**From:** Christine Cross  
**Sent:** 27/02/2024 8:51:28 PM  
**To:** Council Northernbeaches Mailbox  
**Subject:** TRIMMED DA2024/0077 85 Griffith Street, Balgowlah Attention Anaii Sarkissian  
**Attachments:** DA2024\_0077 submission 27 Feb 2024.pdf;

**Submission to Application No. DA 2024/0077  
85 Griffiths Street, Balgowlah**

### Amenity / Overshadowing / Privacy

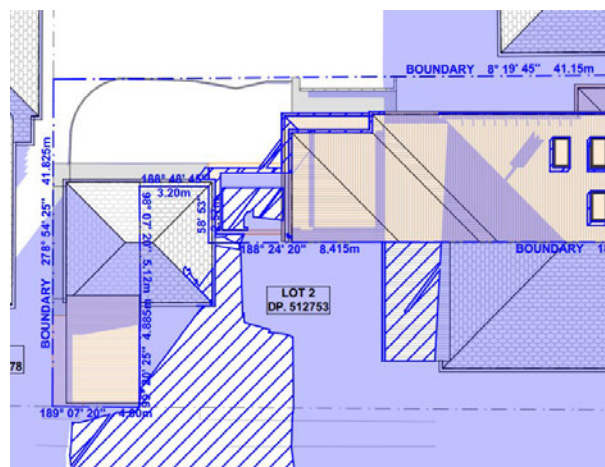
- Drawings DA13 and DA14 show increased shadowing to our property at 12pm and 3pm (also as stated at 3.4 of the SoEE). Our access to sunshine is therefore adversely affected.
  - The development results in substantial overshadowing and will reduce the sunlight reaching our recreation/outdoor living area/yard during the winter months by more than 1/3rd of the existing sunlight as indicated in Drawing No. DA14 Winter Solstice 3pm.
  - **Note:** It is not primarily a hardstand area in front of the garage as suggested at 3.4 of SoEE. This is our main outdoor recreational space/outside living area/the place where we spend the majority of our outside time.

- 3.4 of the SoEE states that privacy will be retained and no overlooking into key living areas. Bedroom 3 at the rear of the development overlooks the rear of our property and as such, will affect our privacy as this is our main outside living area/recreational space.
- 3.4 (p.17, 2nd para) of the SoEE refers to the “solid brick wall on the eastern side”. The eastern side elevation/wall reduces our sunlight and will impact airflow.
- 4.2 (p. 10) of the SoEE states that the proposed development ensures privacy and solar access to our adjoining cottage and remains consistent with the streetscape and the locality. This is incorrect, as detailed above.
- 1.3 (p. 3) of the SoEE states that the proposed alterations and additions are considerate to adjoining neighbours and results in improved amenity. This is incorrect as detailed above.

### Swimming Pool

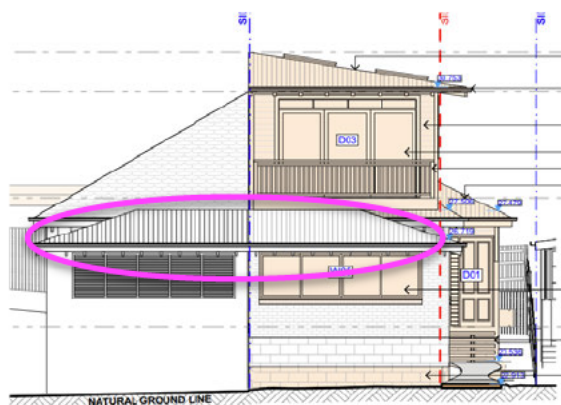
- The swimming pool does not respect the minimum side setback regulation of 1 metre from the boundary and does not leave enough room for acoustic landscaping.
- While not averse to the installation of a swimming pool, we do have concerns of the height of the pool (which is above the floor level of our cottage) and the volume of water being in close proximity to our floor level.
